Baseline Wander causes higher Implementation Loss

November, 2021

Visual comparison of the baseline wander effect.

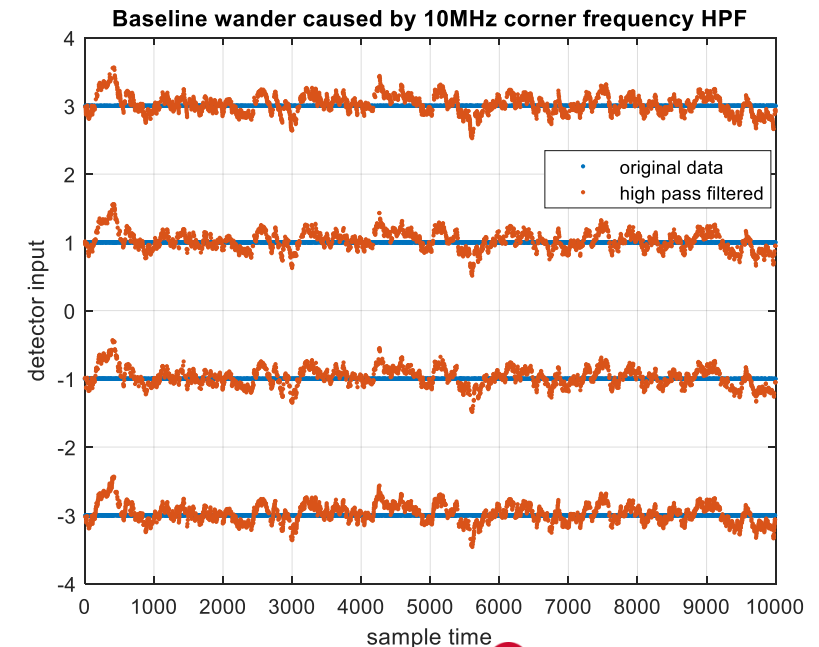
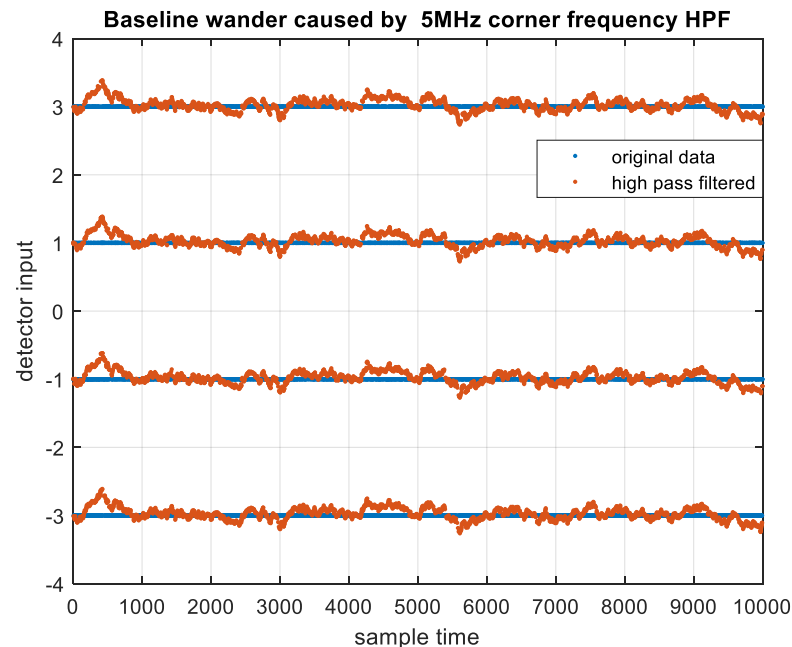
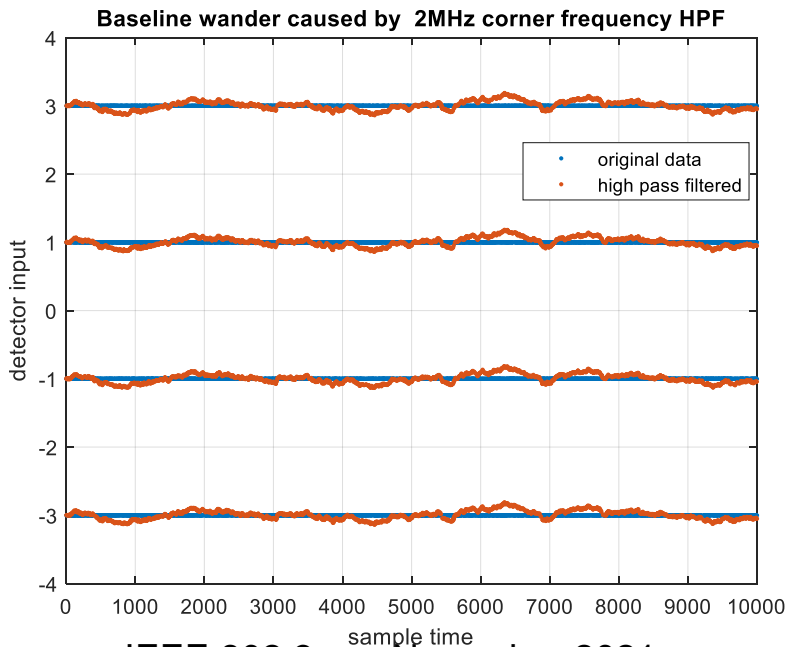
- A double pole high pass filter of given corner frequency.
- Filter PAM4 data using this high pass.
- Baseline wander becomes more pronounced as corner frequency of HPF increases.

Lower PSD mask frequency limit	SNR contribution
1MHz	32.5dB
2MHz	29.6dB
5MHz	25.6dB
10MHz	22.6dB
